Management of Change Guide

KTM™ Series EF1 Two Piece Floating Ball Valves

K-Ball F190 and F190F ball valves are discontinued to be replaced with the new KTM Series EF1. KTM EF190 and EF190FE are consolidated under Emerson's new two piece, split body floating ball valve platform, the KTM Series EF1.

4. K-Ball F190/F190F Obsolescence

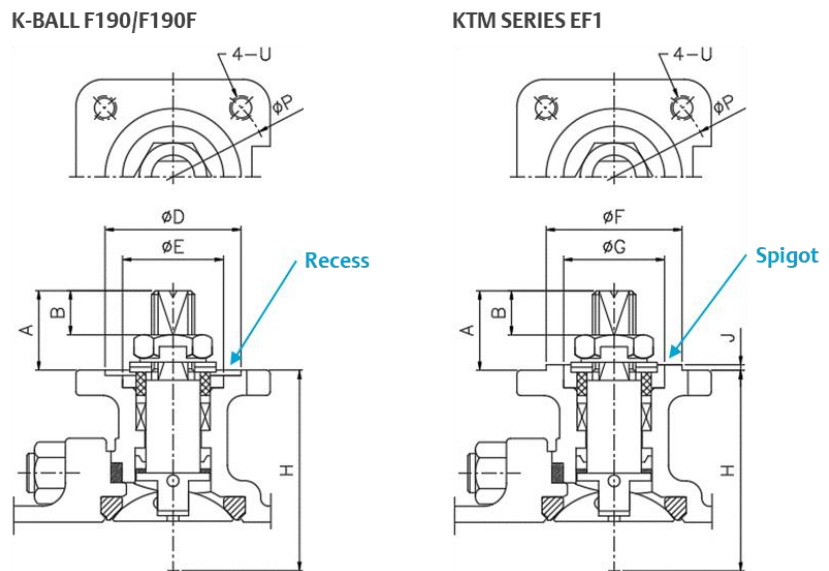
The main difference between the K-Ball F190/F190F and the KTM EF190/EF190FE is the locating spigot on top of the valve. As the product lines are consolidated into the KTM Series EF1, the K-Ball F190 /F190F recessed top plate design will be discontinued and spigot top plate design will become the standard design for the new KTM Series EF1. These changes dimensional changes are described in detail in the following section.

5. Top Mounting Plate Dimensions

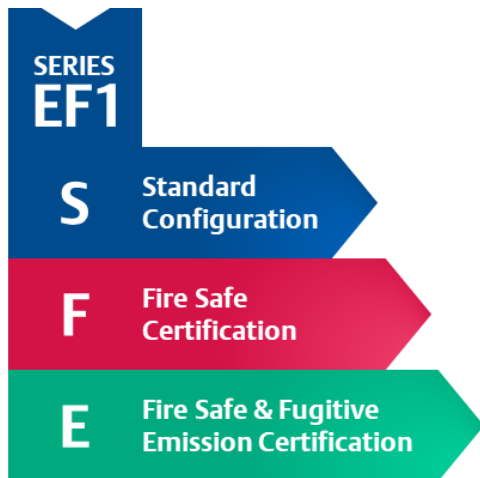
For customers transitioning from the K-Ball Figure 190 and Figure 190F to the KTM Series EF1 ball valve, there is one key difference to note regarding the mounting plate.

The KTM Series EF1 floating ball valve features a spigot mounting plate design, whereas the K-Ball Figure 190/190F featured a recess.

The resulting dimensional differences are outlined in the table below. All other components and key dimensions remain the same.
